UNITED STATES PATENT AND TRADEMARK OFFICE

APPLICATION NO.	FILING DATE	FIRST NAMED INVENTOR	ATTORNEY DOCKET NO.	CONFIRMATION NO.
10/033,113	10/25/2001	Allan Charles Acciaccia	DP-305859	7686

Office Action Summary

DETAILED ACTION

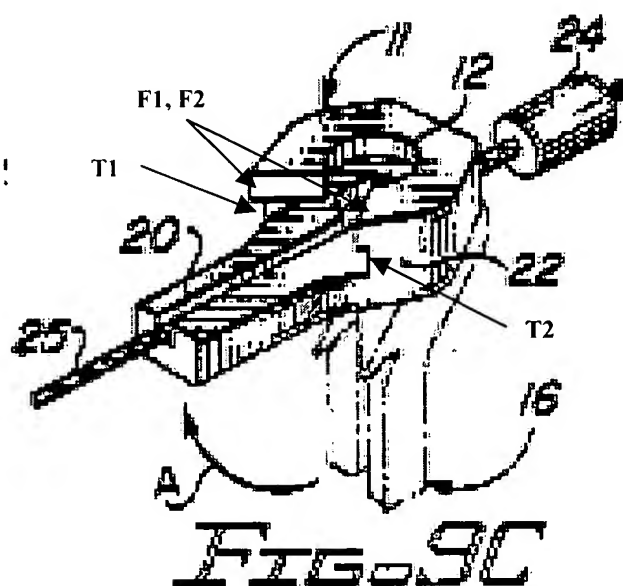
a. Claim 1. Lundeen specifically shows a cable attachment for attaching a cable **25** to an end portion of a member **11** comprising the member **11** having an open ended loading slot **12** that extends into the end portion of the member **11** to an inner end forming separate cantilevered fingers **F1**, **F2** on opposite sides of the loading slot **12**, the loading slot **12** spanning the separate fingers **F1**, **F2** to form openings between the fingers **F1**, **F2** at opposite sides of the end portion, the end portion having a retaining slot **20**, **21**, **19** that is transverse to the loading slot **12**, the loading slot **12** having an inner end portion

and the retaining slot having an outer end portion that overlaps the inner end portion of the loading slot 12, the end portion having a first transition slot T1 that extends from one of the opposite sides 22 of the end portion through one of the fingers F1 into the inner end portion of the loading slot 12 and the overlapping outer end portion of the retaining slot 20, 21, 19, the end portion having a second transition slot T2 that extends from another of the opposite sides 22 of the end portion through another of the fingers F2 into the inner end portion of the loading slot 12 and the overlapping outer end portion of the retaining slot 20, 21, 19, and the cable 25 extending through the retaining slot 20, 21, 19 and having a ferrule 24 that engages a surface of the end portion adjacent the retaining slot 20, 21, 19 for moving the member 11, the cable 25 being moveable axially in the retaining slot 20, 21, 19 to form a lost motion attachment with the end portion of the member 11 (see figures 1-5 and 9A, 9B, 9D, and 9E and annotated figure 9C below; column 3 line 40 – column 4 line 61).

- b. Claim 2. Lundeed, as applied to claim 1 above, also shows the cable **25** loaded into the retaining slot **20, 21, 19** through the loading slot **12** and the first and the second transition slots **T1, T2** (see annotated figure 9C above).

- c. Claim 3. Lundeed also shows the second transition slot **T2** is coplanar with the first transition slot **T1** (see annotated figure 9C above – plane parallel to surface **11**).

- d. Claim 4. Lundeed also shows the retaining slot as being linear (see annotated figure 9C above).
- e. Claim 5. Lundeed also shows that the retaining slot **20, 21, 19** is shaped to inhibit escape of the cable **25** transverse to its axis (see especially figure 9B).

- f. Claim 8. Lundeed, as applied above, shows a cable attachment for attaching a cable **25** to an end portion of a moveable member **11** comprising the member **11** having an open ended loading slot **12** that extends into the end portion of the member **11** to an inner end forming separate cantilevered fingers **F1, F2** on opposite sides of the loading slot **12**, the loading slot **12** spanning the separate fingers **F1, F2** to form openings between the fingers **F1, F2** at opposite sides of the end portion, the end portion having a retaining slot **20, 21, 19** that is perpendicular to the loading slot **12**, the loading slot **12** having an inner end portion and the retaining slot **20, 21, 19** having an outer end portion that overlaps the inner end portion of the loading slot **12**, the end portion having a first transition slot **T1** that is perpendicular to the loading slot **12** and the retaining slot **20, 21, 19** and that extends from one of the opposite sides **22** of the end portion through one of the fingers **F1** into the inner end portion of the loading slot **12** and the overlapping outer end portion of the retaining slot **20, 21, 19**, the end portion having a second transition slot **T2** that is aligned with the first transition slot **T1** and that extends from another of the opposite sides **22** of the end portion through another of the fingers **F2**

into the inner end portion of the loading slot **12** and the overlapping outer end portion of the retaining slot **20, 21, 19**, and the cable **25** extending through the retaining slot **20, 21, 19** and having a ferrule **24** that engages a surface of the end portion adjacent the retaining slot **20, 21, 19** for moving the member **11**, the cable **25** being moveable axially in the retaining slot **20, 21, 19** to form a lost motion attachment with the end portion of the moveable member **11** (see figures 1-5 and 9A, 9B, 9D, and 9E and annotated figure 9C above; column 3 line 40 – column 4 line 61).
